Florida Department of Transportation

RE: Variance Committee Review to allow for **Category F Driveway**

Project Name & Address: K-Park - 10400 Stribling Way

AMRC Meeting Date: 9/4/2025, 11:15 AM

OPTION 2G
FULL TRAFFIC SIGNAL
W/ INTERNAL ROUNDABOUT

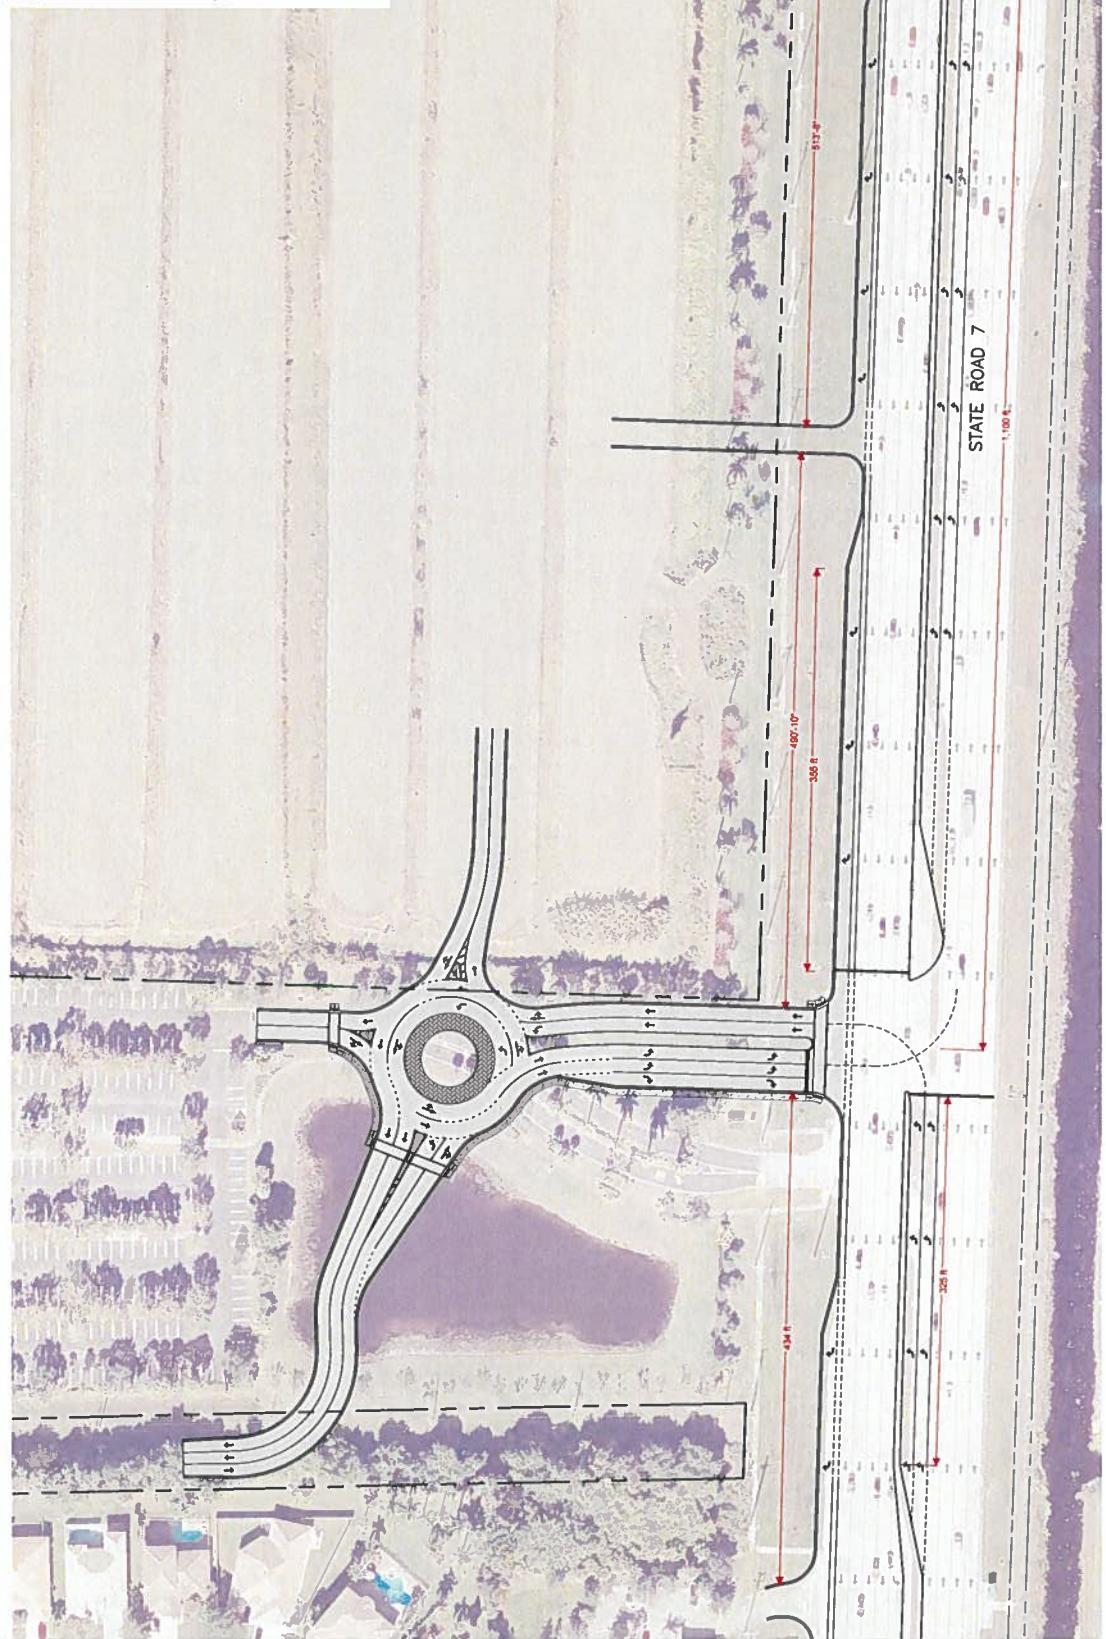
- **Driveway 1:** Proposed right-in/right-out driveway with right turn lane on the west side of SR 7, located approximately 514 feet south of Stribling Way.
- **Driveway 2:** Proposed signalized intersection on SR 7, located approximately 1,029 feet south of Stribling Way.
- Close the existing right-in/right-out/left-in driveway on the west side of SR 7, located approximately 1,153 feet south of Stribling Way.
- Remove the existing directional median opening on SR 7, located approximately 1,029 feet south of Stribling Way.

- Driveway 1** shall have a minimum driveway length of 100 feet, measured from the ultimate right-of-way line to the first conflict point in the driveway.
- The proposed signalized intersection (Driveway 2) shall have a minimum driveway length determined by a traffic study conducted by the applicant.
- The proposed multilane roundabout shall follow nationwide design guidelines (FDOT FDM Chapter 213). Queuing from the multilane roundabout's eastern approach must not encroach onto SR 7, as determined by a traffic study conducted by the applicant at permit.
- Right turn lanes are required for Driveways 1 & 2 and shall meet the minimum requirements in the Florida Design Manual (FDM) and shall provide space for a buffered bicycle lane.

- The queue length for the proposed northbound dual left turn lanes at Driveway 2 and the proposed dual northbound left turn lanes at the intersection of SR 7 and Stribling Way, must be determined by a traffic study conducted by the applicant at permit.**

- An Intersection Control Evaluation (ICE) Analysis conducted by the applicant at permit, is required for Driveway 2.**
- The proposed traffic signal support system shall have the structural capacity to implement a minimum of one signal head per lane with five section heads for all three approaches, as needed.**

- The following off-site improvements shall be implemented at the intersection of SR 7 & Stribling Way, by the applicant:**
 - An additional northbound left turn lane. The intersection shall be served by dual northbound lefts.**

- An additional eastbound right turn lane.**
 - An additional eastbound left turn lane.**
 - Extend the southbound right turn lane to meet minimum length as determined by a traffic study conducted by the applicant at permit.**

This request is: **Approved with Conditions**
